**City of Salmon Arm  
Development and Planning Services  
Committee**

**Monday, June 17, 2019  
8:00 a.m.  
Council Chambers, City Hall  
500 – 2 Avenue NE**

Subject: Development Variance Permit Application No. VP-498 (Parcel Line Setbacks)  
 Legal: Parcel A (Plan B5360) of Lot 1, Section 14, Township 20, Range 10, W6M, KDYD, Plan 2985, Except Plan 5725  
 Civic: 451 – 10 Avenue SE  
 Owner / Applicant: Varga, J.

SUBJECT: Development Variance Permit Application No. VP-497  
 Legal: Lot 1, Section 6, Township 20, Range 9, W6M, KDYD, Plan 41074  
 Civic Address: 4921 Auto Road SE  
 Owner: The Wood Shop Millwork & Joinery Inc.  
 Applicant: Owners (S. Bird & T. Johnston)

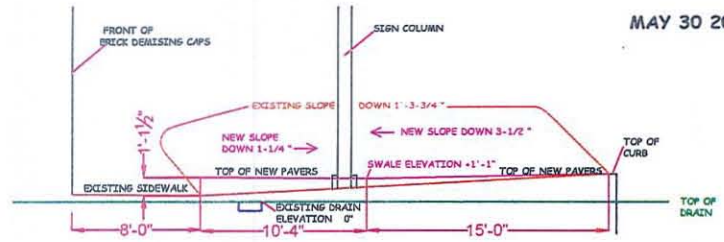
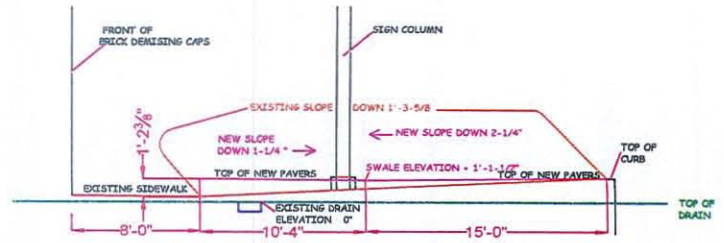
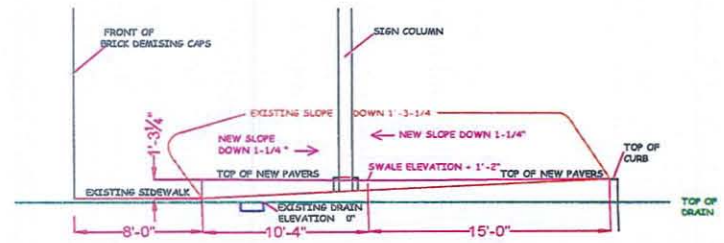
- 1) The structure proposed on the City Boulevard of Lakeshore Drive is considered by staff to be "Public Art" and it would have a height of 44.5 ft. and a width of 29.5 ft. It would be a significant structure visible from many vantage points. (The former Askew's Freestanding Sign had a height of approx. 30 ft., which was approved by City Council in 2002 with a Sign Bylaw Variance.)
- 2) The art structure would be made from powder coated aluminum slightly > 1 inch in thickness and weigh slightly over 1,000 Lbs.
- 3) We do not see this Public Art at falling into the realm of the Sign Bylaw.
- 4) The Public Art does not fall into the realm of the Highway Use Permit.
- 5) City Council's approval would be required.

Although Maurice suggests a Building Permit would not be required for a Public Art installation on the City's boulevard, staff (collectively) will be recommending three (3) conditions to City Council if they approve the installation:

- 1) That the installation be stamped/approved by a Registered Professional (i.e. structural engineer);
- 2) That appropriate liability insurance saving the City Harmless be placed on the structure; and
- 3) That you propose a maintenance and ownership plan for Council's consideration.

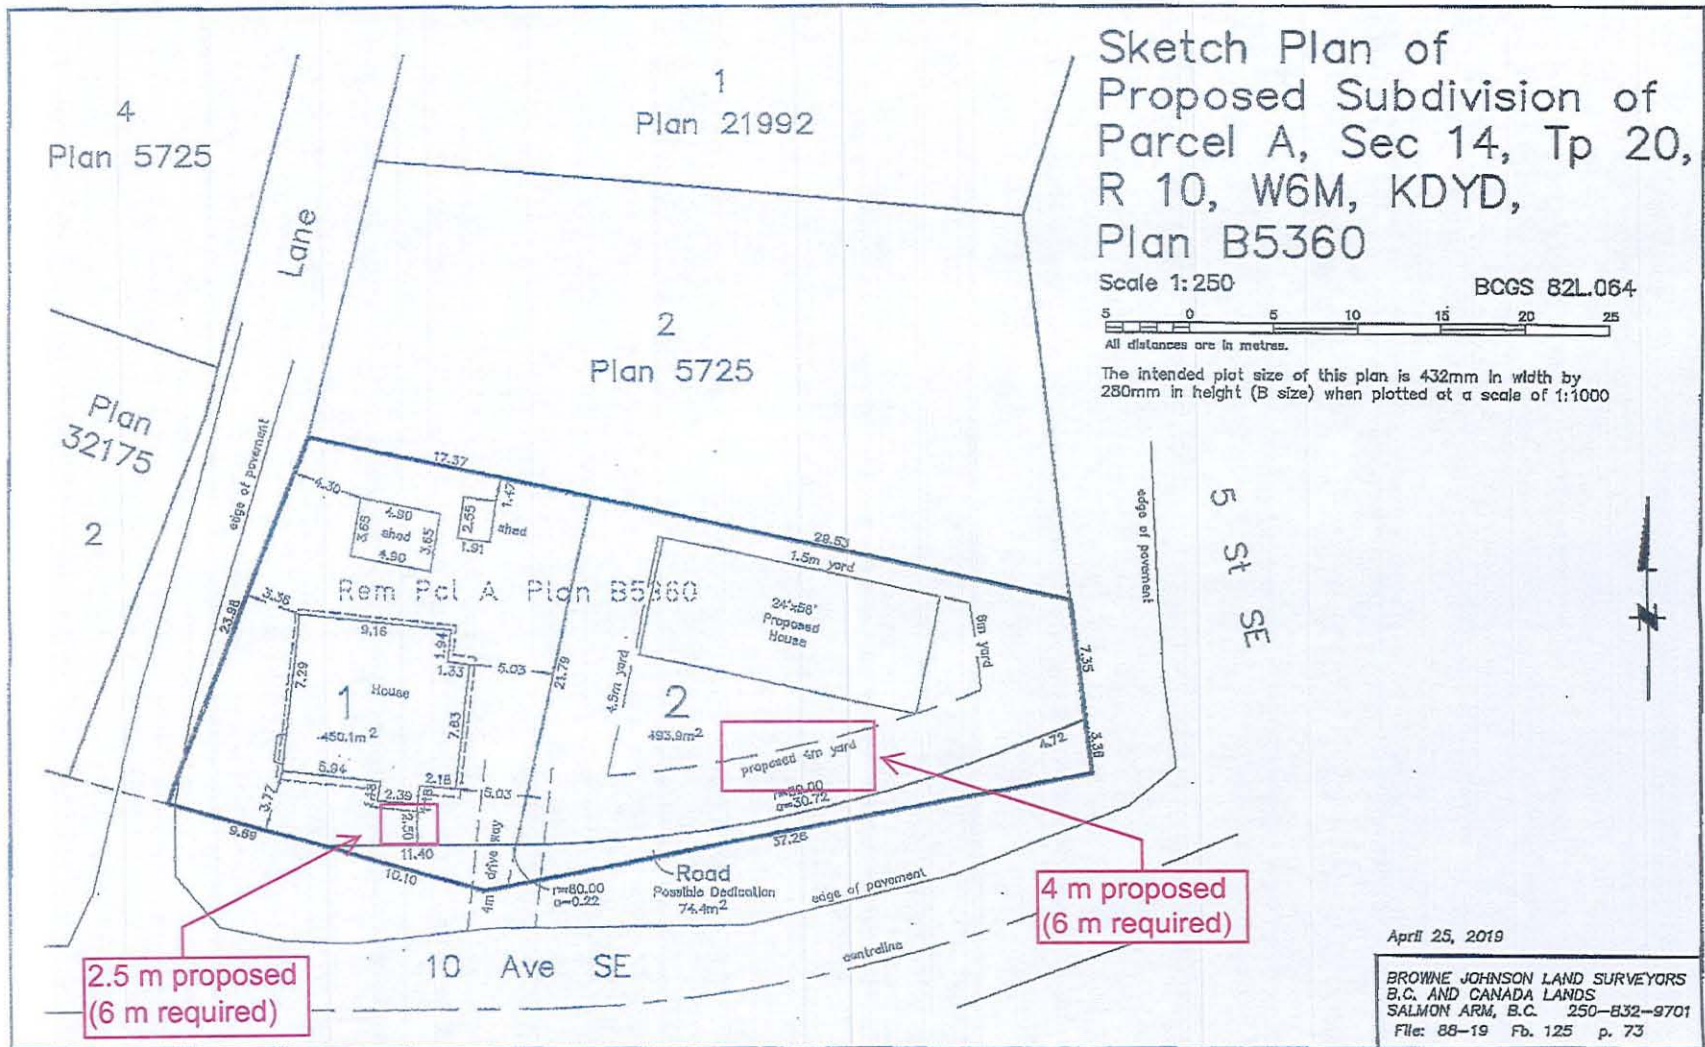
With respect to the permitted 1.5 m setback on the north property line, this may cause some concern with limiting distance. Only 8 % of the facing wall would be permitted as glazed openings. No other concerns.

Setback regulations on corner parcels enable adequate separation between buildings and streets for aesthetic, privacy, view preservation, and traffic safety reasons. While staff note that the subject property is within an area designated for high density residential development, as well as future road widening, the proposal would support a relatively minor existing non-conformity, and would not encroach further into the setback areas. In terms of neighbourhood design, the subject property is within an established residential neighbourhood and is consistent with neighbouring parcels. Staff note that the home has been at its present location for decades without significant concerns. The requested setback reductions will not impact City utilities, pose any BC Building Code concerns, or restrict future development on neighbouring lots.

Considering the conditions noted above, the variances requested in this proposal do not significantly concern staff and are viewed as reasonable.

If approved, Development Variance Permit No. VP-498 will only be applicable as shown in Appendix 1: Schedule A.

45 m. Radius From Hydrant

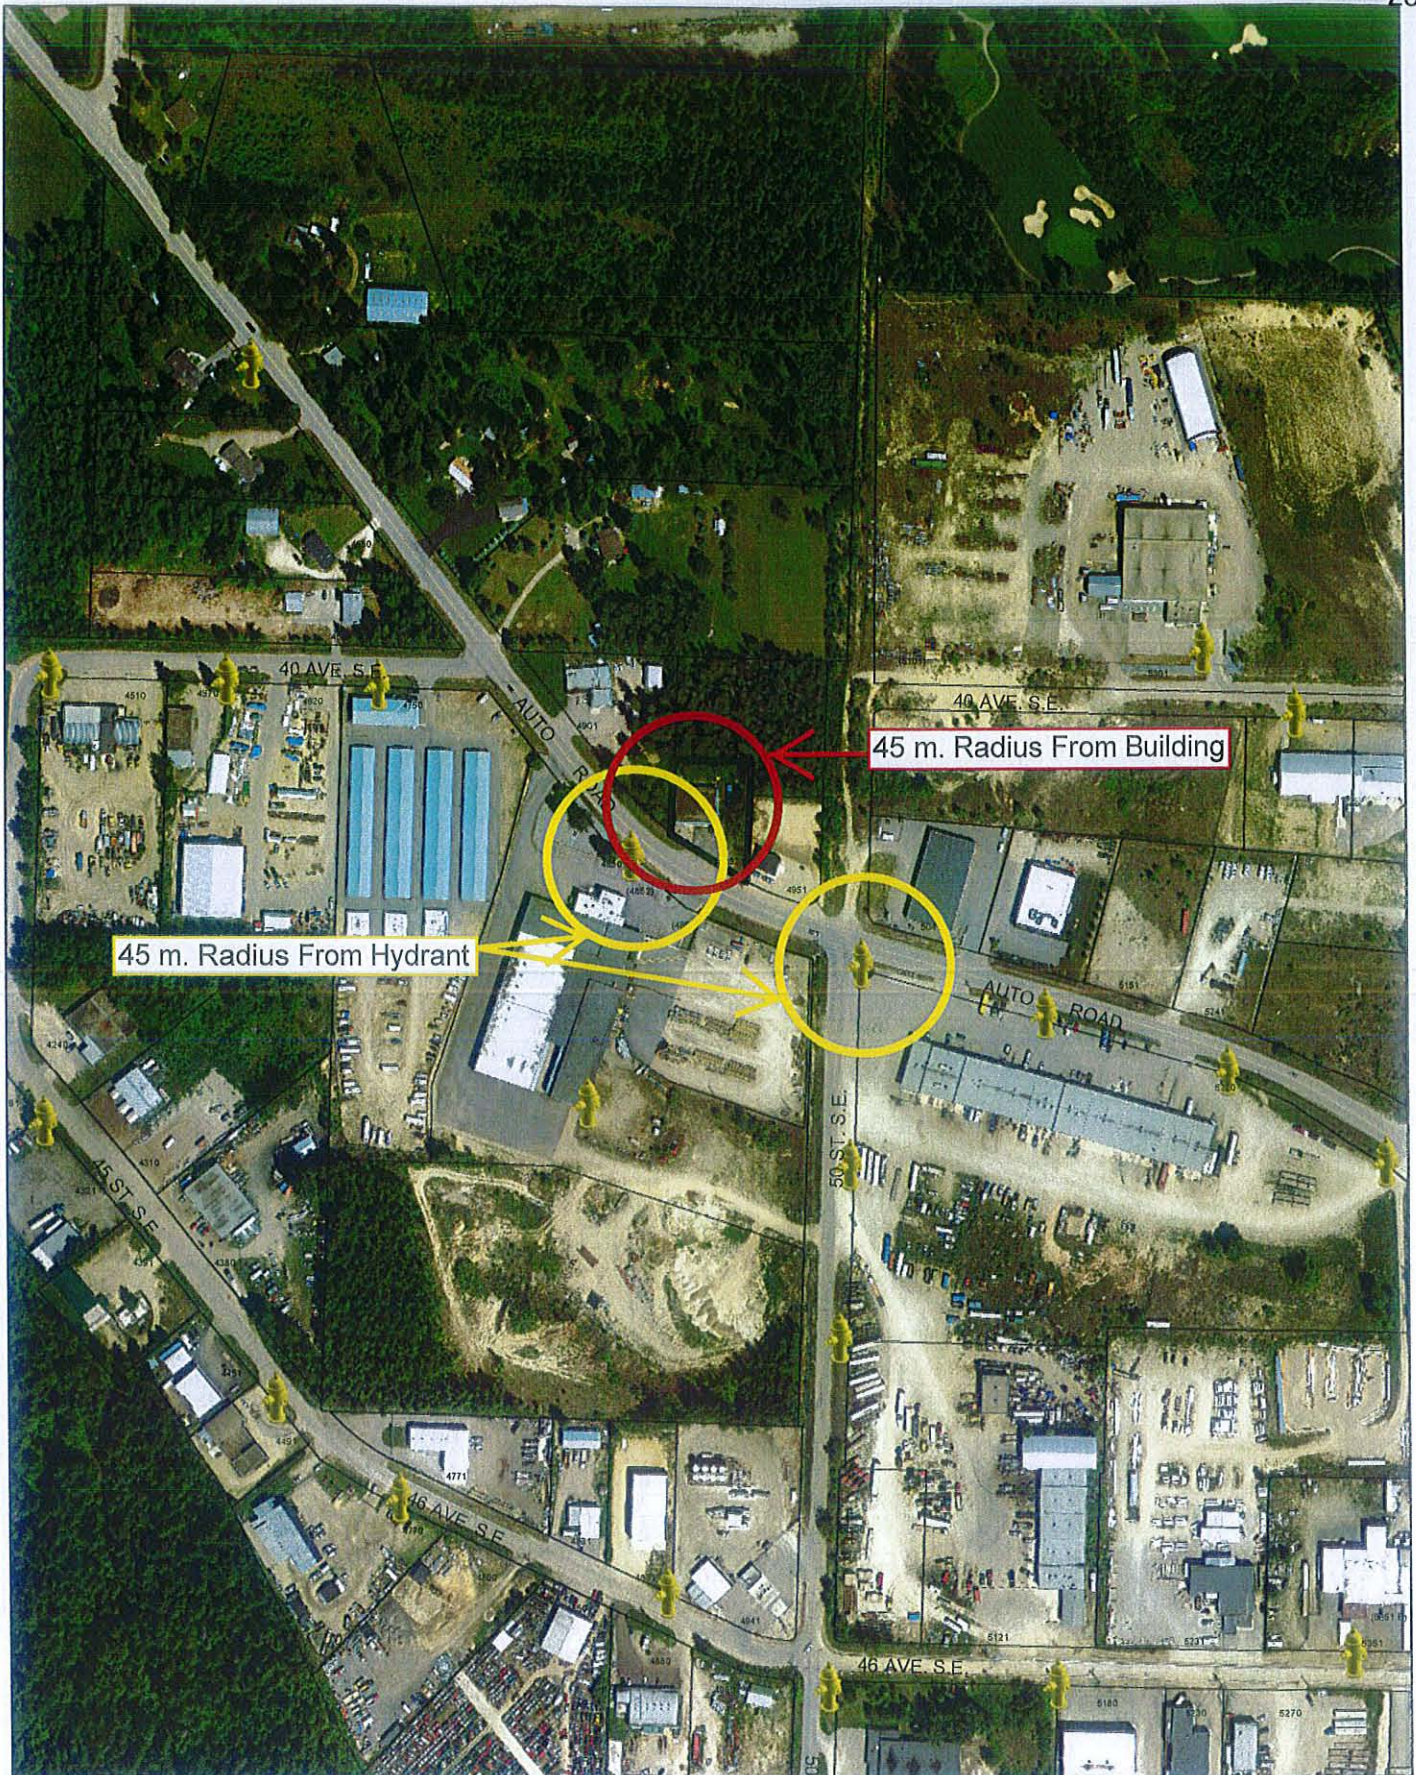
There are two existing fire hydrants within proximity of the subject property along Auto Road. The building is within a 45 m radius to the closest fire hydrant. However, the frontage of the property extends outside of the allowable spacing; thus, a fire hydrant is required to meet the 90 metre spacing as specified in the Subdivision & Development Servicing Bylaw (Appendix 7).

COMMENTS for VP-497  
Further to my visit to the business located at 4921 auto road S.E, my opinion is the fire department would have no problems in combatting a fire and establishing a sufficient water supply from fire hydrants located adjacent to this property.

**The Engineering Department strongly recommends that the requirement to waive the installation of a fire hydrant be denied.** Setting a precedent of waiving safety related requirements against the recommendation of FUS would likely cause liability issues for the City and creates a grey area for applicants on City requirements.

80 m. Radius From Property

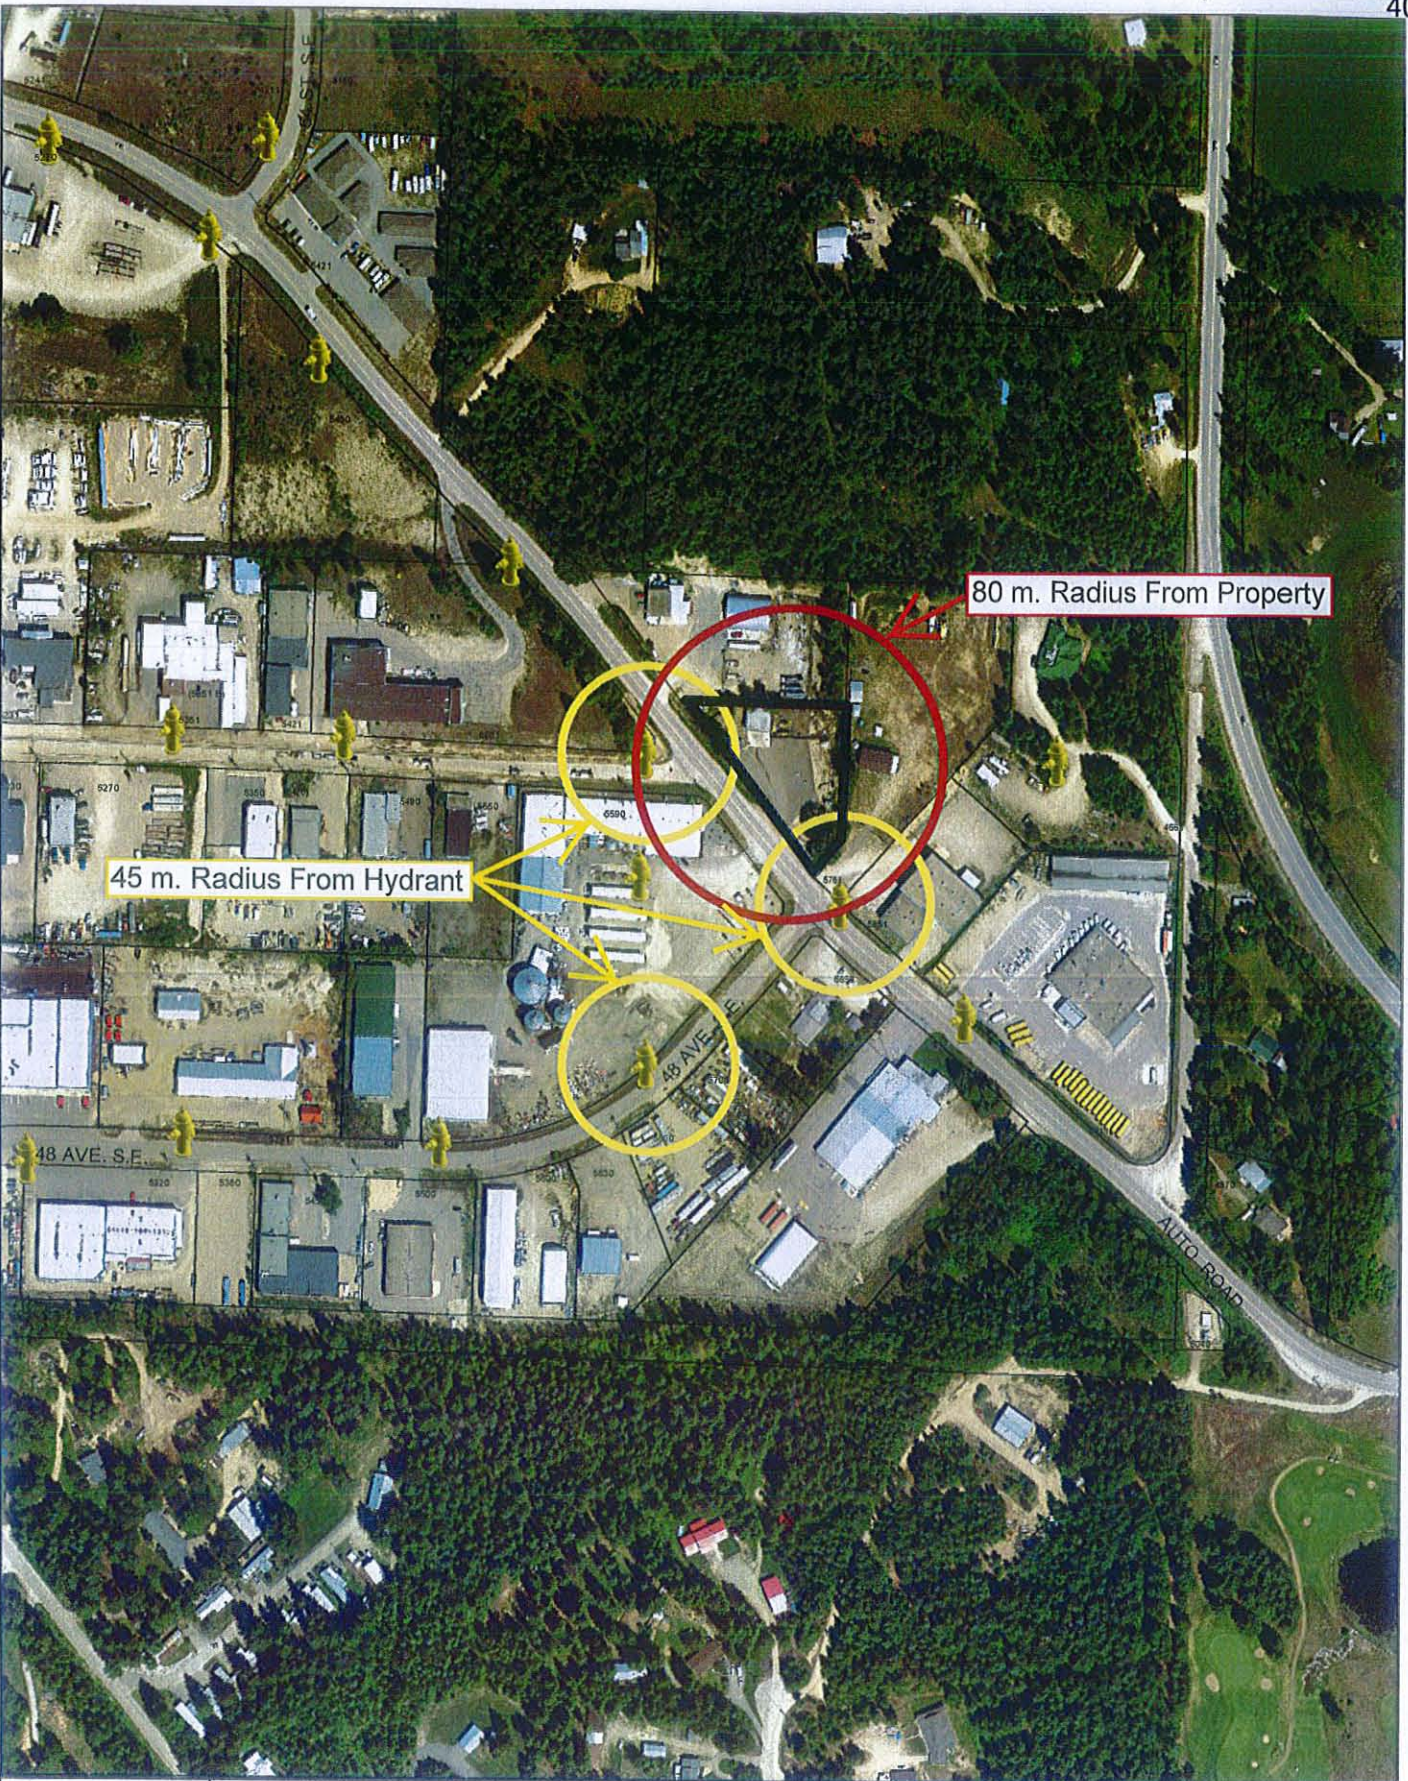
There are two existing fire hydrants within a 80 metre radius of the subject property along Auto Road. These two existing fire hydrants are spaced approximately 130 metres apart, thus not meeting the required minimum spacing of 90 metres as specified in the Subdivision & Development Servicing Bylaw (Appendix 7).

Further to my visit to the business located at 5731 auto road S.E, my opinion is the fire department would have no problems in combatting a fire and establishing a sufficient water supply from fire hydrants located adjacent to this property.

**The Engineering Department strongly recommends that the requirement to waive the installation of a fire hydrant be denied.** Setting a precedent of waiving safety related requirements against the recommendation of FUS would likely cause liability issues for the City and creates a grey area for applicants on City requirements.
